ADDENDUM '04'

Project Name Collingwood Green Phase 3
Toledo, Ohio

Addendum Date: March 01, 2017

SITE DEVELOPMENT FOR:
COLLINGWOOD GREEN PHASE III
CITY OF TOLEDO, LUCAS COUNTY, OHIO
BLOCK C
-- PROPOSED SITE GEOMETRICS --

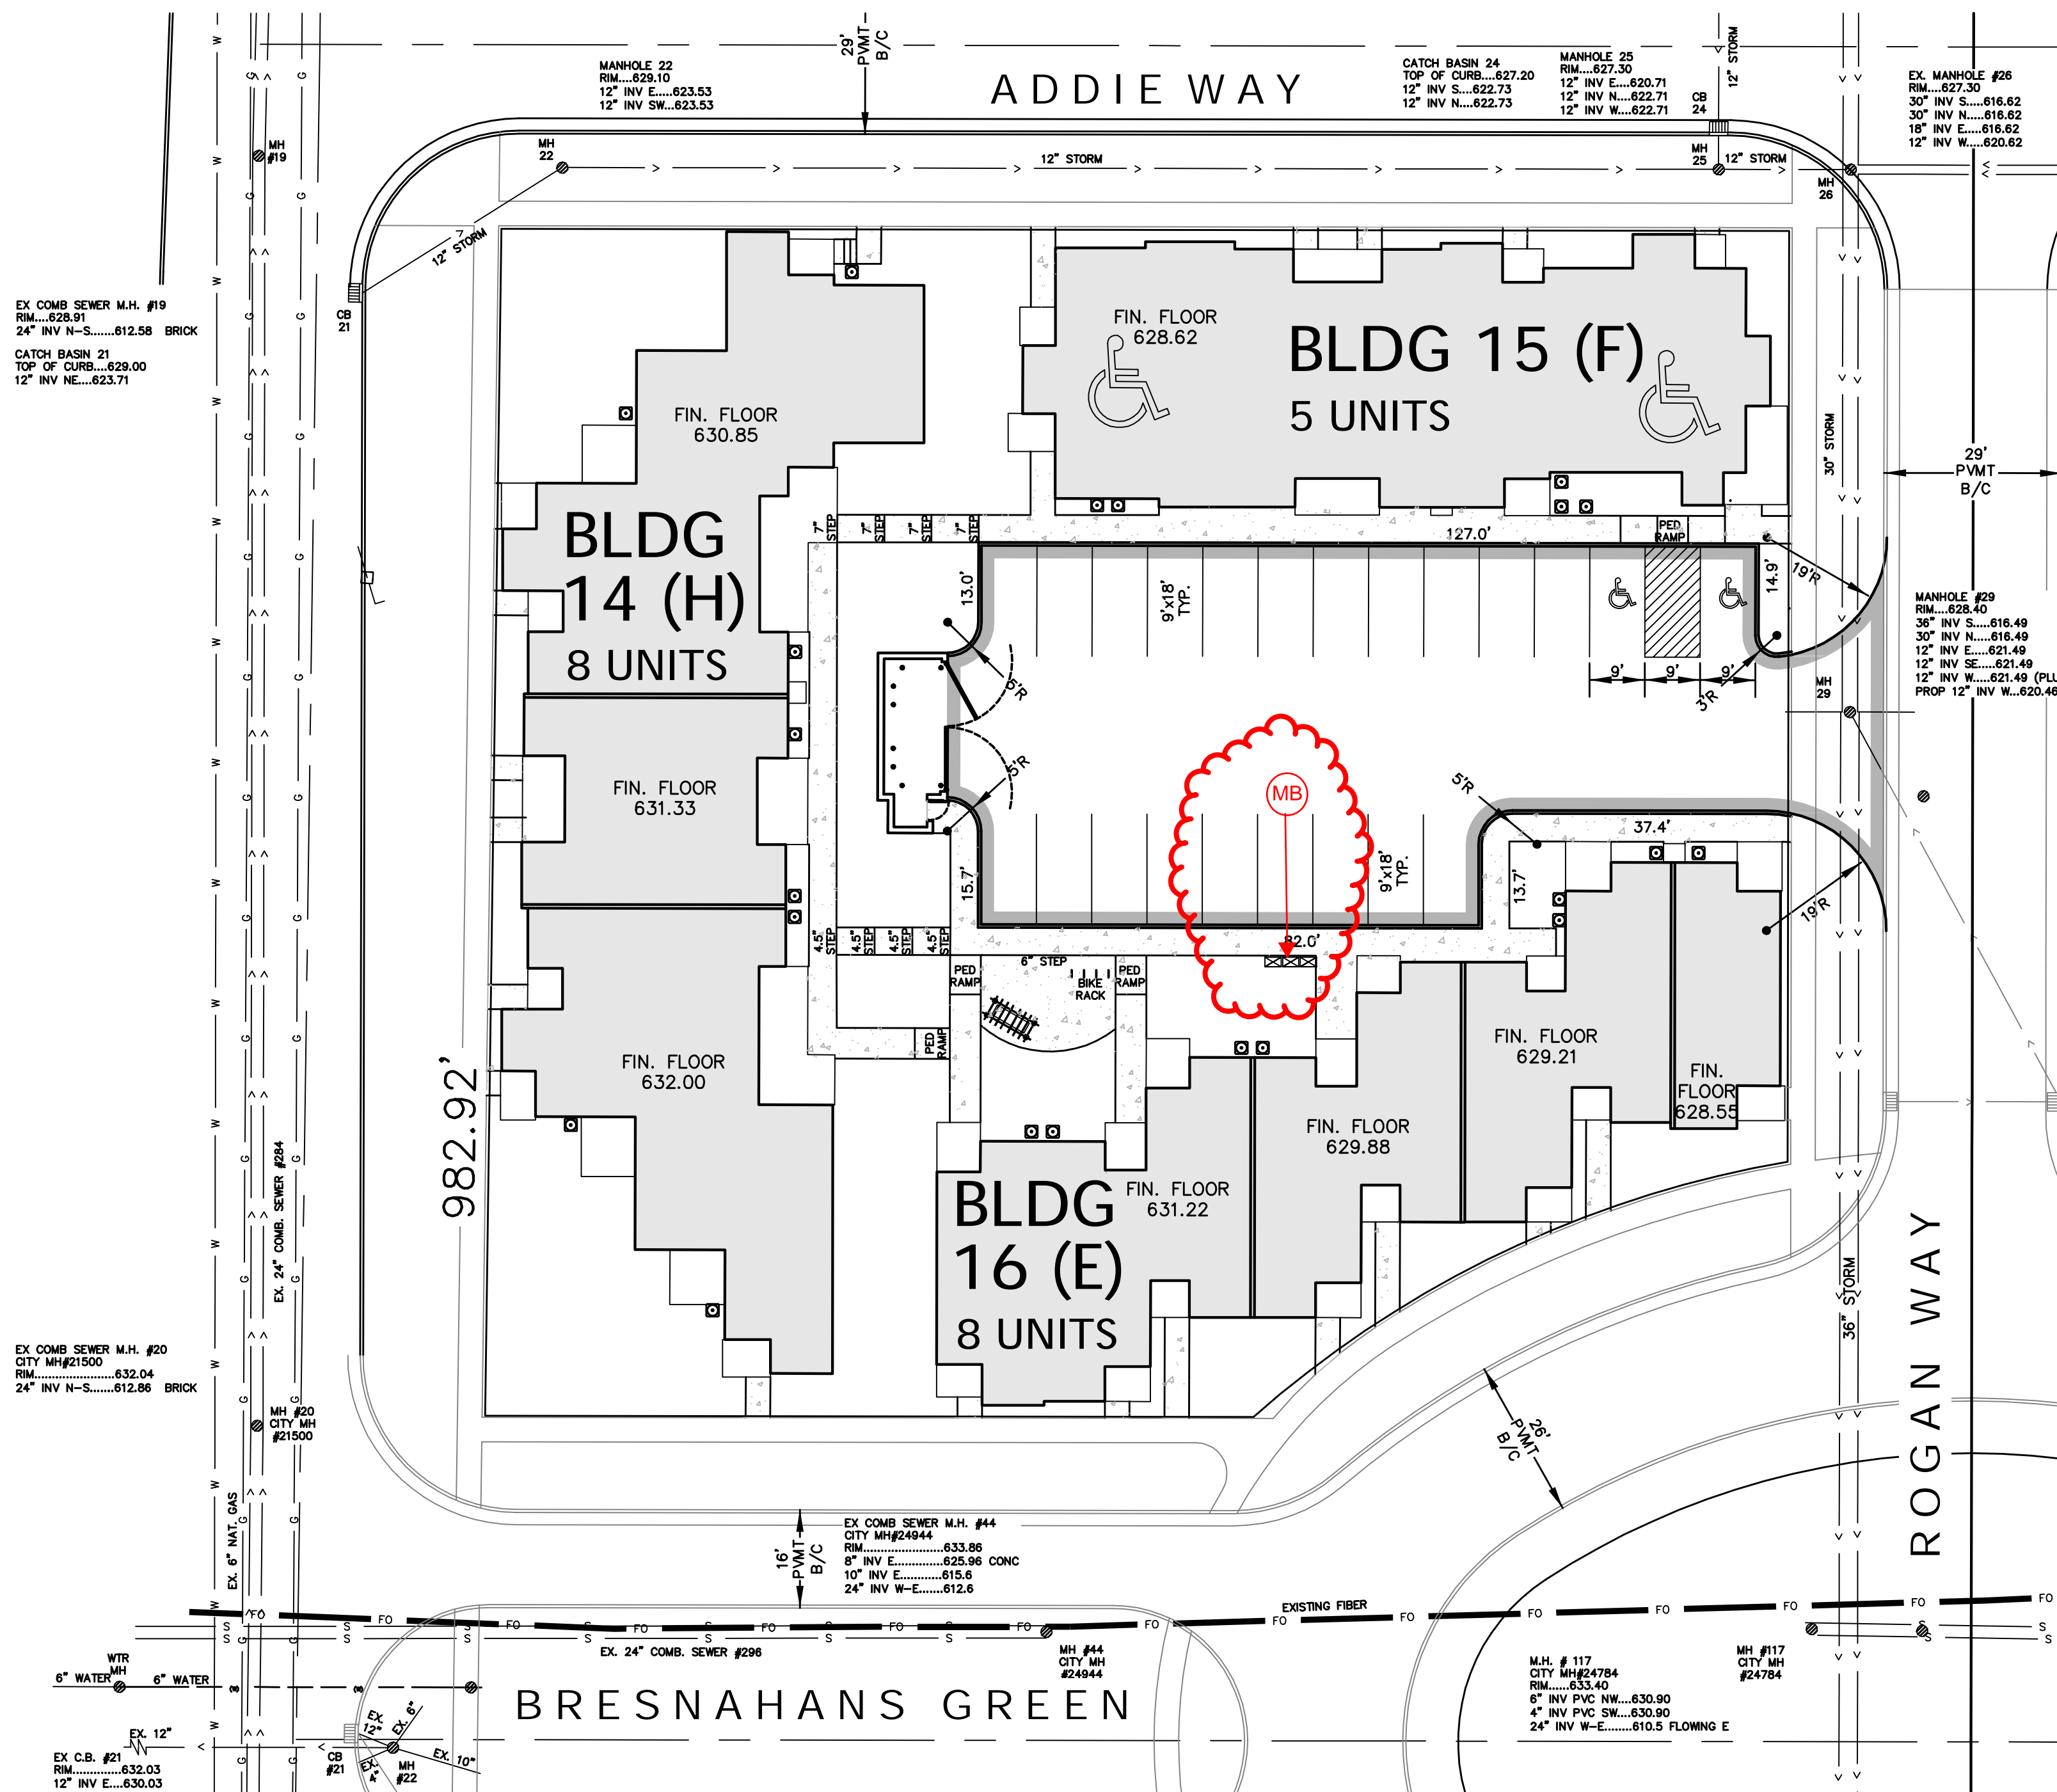
- 1. **Cluster Mailboxes:**
 - a. Tag identifying location of Cluster Mailbox for Block C, Block D and Block E has been added to Sheet 8/17, Sheet 12/17 and Sheet 16/17. Please note the Cluster Mailbox for Block C is existing.
 - b. Refer to attached cut sheet for detail of Cluster Box Unit model WL-4CADD-10-PBM as manufactured by Florence Manufacturing.
- 2. **Site Furnishings:**
 - a. One bench at each block to be supplied per attached specification.
 - b. One Arbor to be provided at each block per attached cut sheet.

Cluster Mailbox
See Spec and Detail A
Sheet 12/17

SITE DEVELOPMENT FOR:
COLLINGWOOD GREEN PHASE III
CITY OF TOLEDO, LUCAS COUNTY, OHIO
BLOCK D
-- PROPOSED SITE GEOMETRICS --

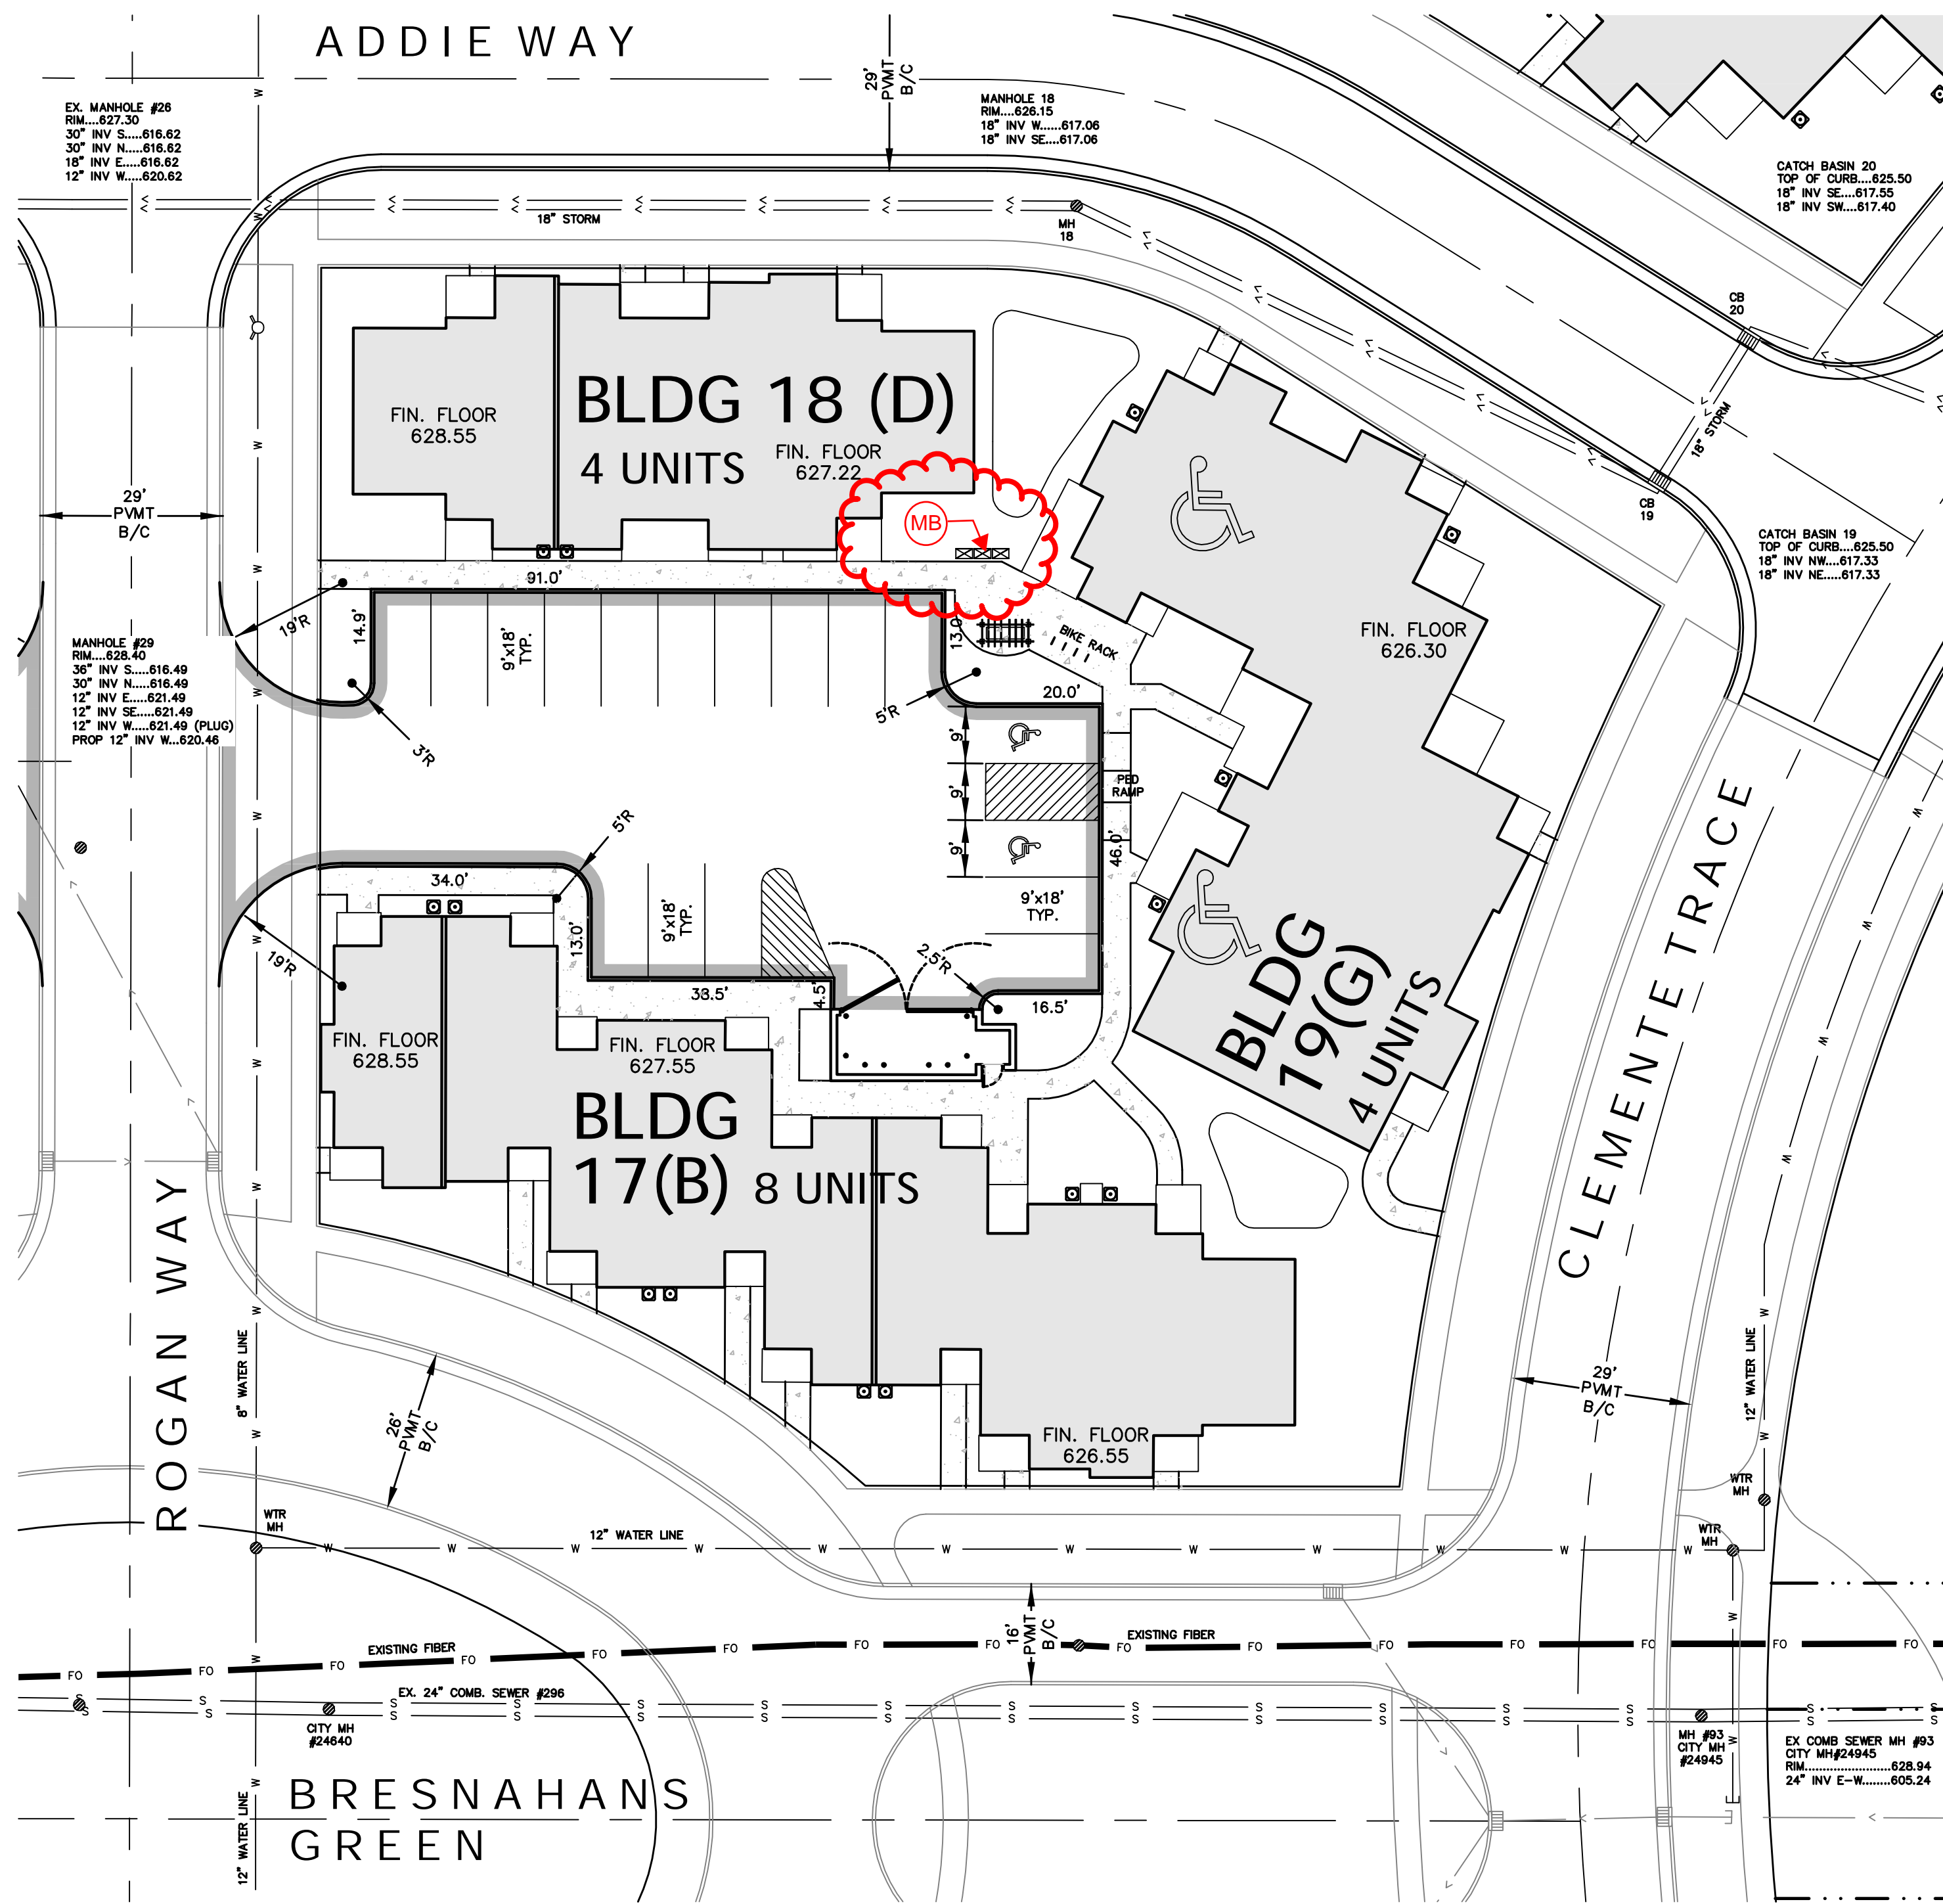
Add Cluster
Mailbox Detail
Plan and
Elevation

radon pit detail

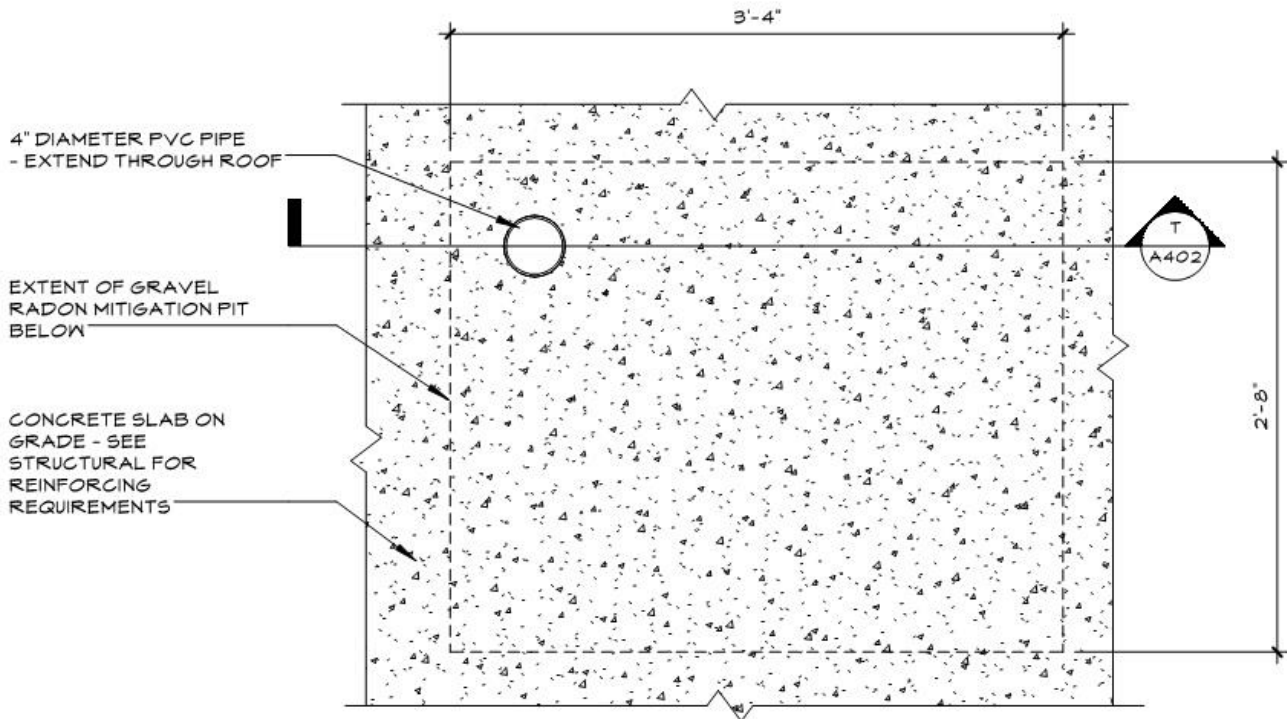
- 1. Radon Mitigation: one radon mitigation pit and stack to be supplied at each building per attached detail sheet. Provide electrical junction box on roof for future fan at each stack location. Pipe will be enclosed in wall construction; location to be determined.
